Type Coffee Vending Machine	Model 9100 - 95	N° T.I. 05 - 2022	
Serial Number 20421288	Subject NEW ACTUATION BOARD	ISSUED FOR (X)	Action Information X

Type Coffee Vending Machine	Model 9100 - 95	N° T.I. 05 - 2022					
Serial Number 20421288	Subject NEW ACTUATION BOARD	ISSUED FOR (X)	<table border="1"> <tr> <td>Action</td> <td></td> </tr> <tr> <td>Information</td> <td>X</td> </tr> </table>	Action		Information	X
Action							
Information	X

New actuation board

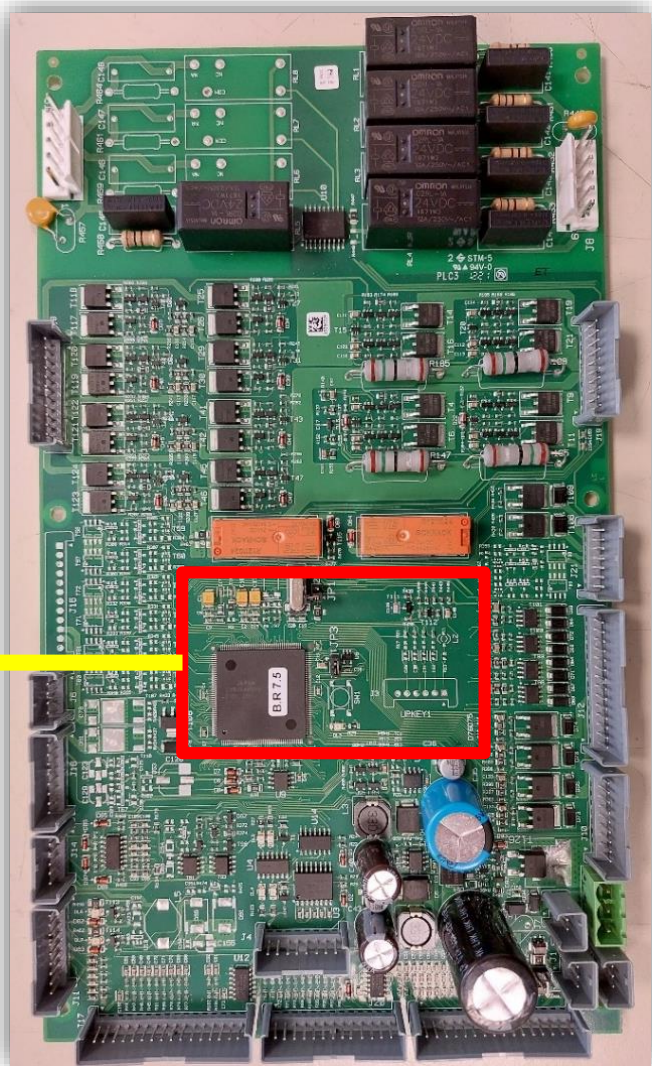
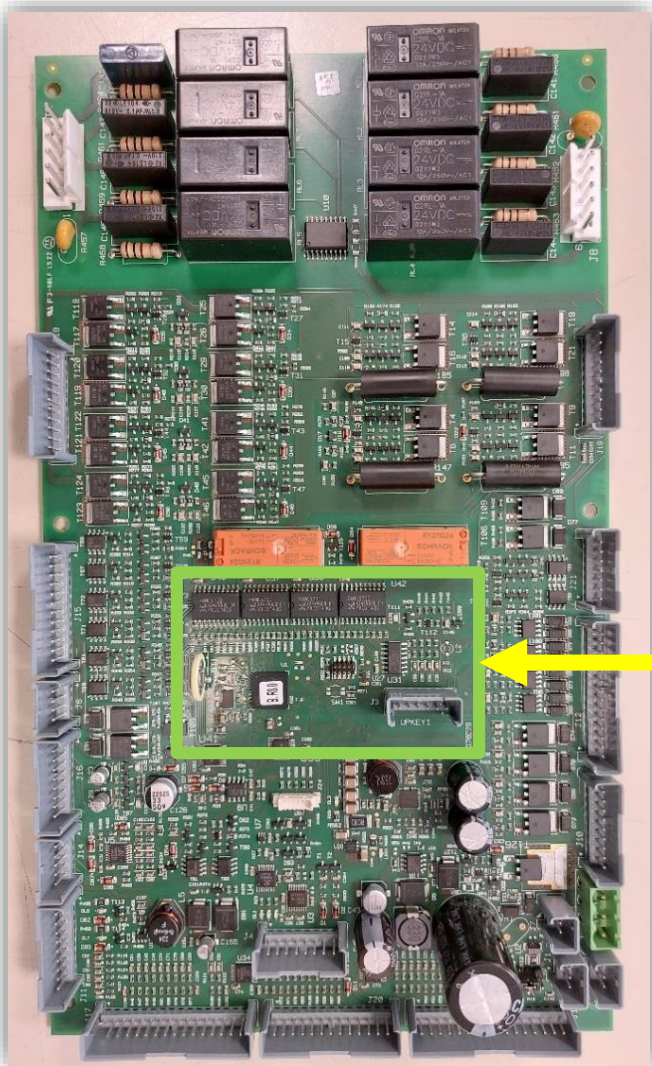
Due to the lack of *microprocessors* present on the *actuation board*

A **new** *actuation board* is introduced. The main difference between the old and the new actuation board is the microprocessor and the related power supply circuit.

Important note: the **new** board must be combined with *new SW versions* below.

The **new** *actuation board* (spare code: **265409**) can be mounted on machines prior to the above S/N in place of the **pre - modification** *actuation board* (spare code: **261899**), by installing the new SW.
